Submission to the Independent Planning Commission

Glebe Island Concrete Batching Plant and Aggregate Handling Facility SSD 8544

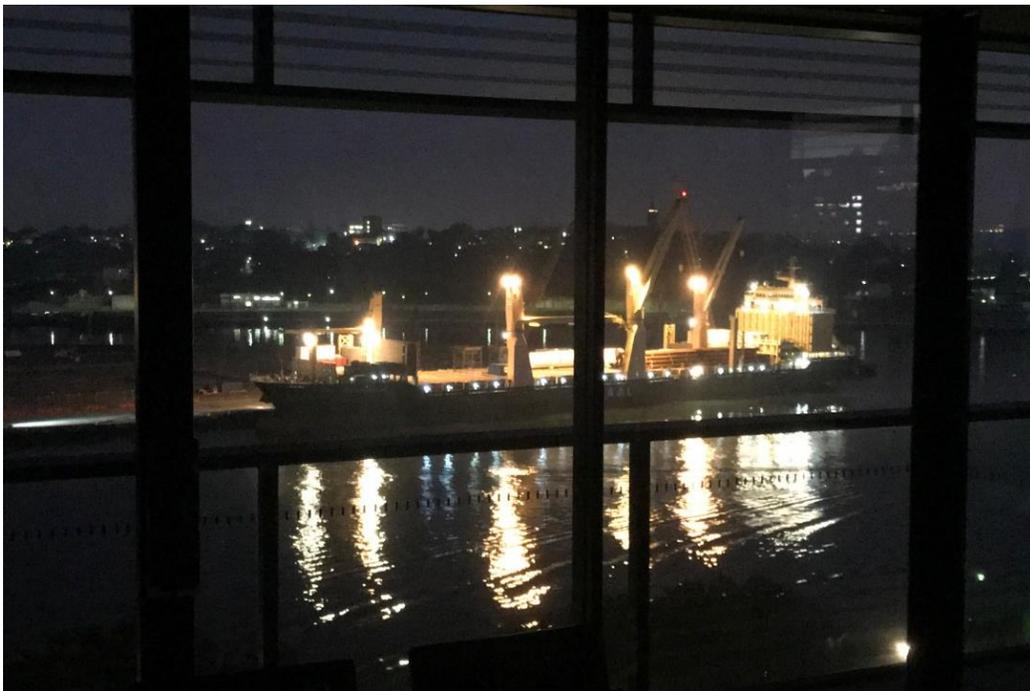
Two figures stand out. The height of the ANZAC bridge deck “at the pylon structure closest to the proposed development” is 30.6 ms and the height of the aggregate storage silos would be 37.6 ms. That means that the silos would be 7 ms higher than the ANZAC bridge carriageway. That is a huge difference. The silos would effectively tower over the carriageway.

This height difference would be reflected in the major adverse impact of the silos on both views of the ANZAC bridge from Pyrmont, Balmain, Barangaroo, and elsewhere, and views from a large section of the bridge to Balmain, North Sydney, the Harbour Bridge, Barangaroo, the CBD, and Pyrmont.
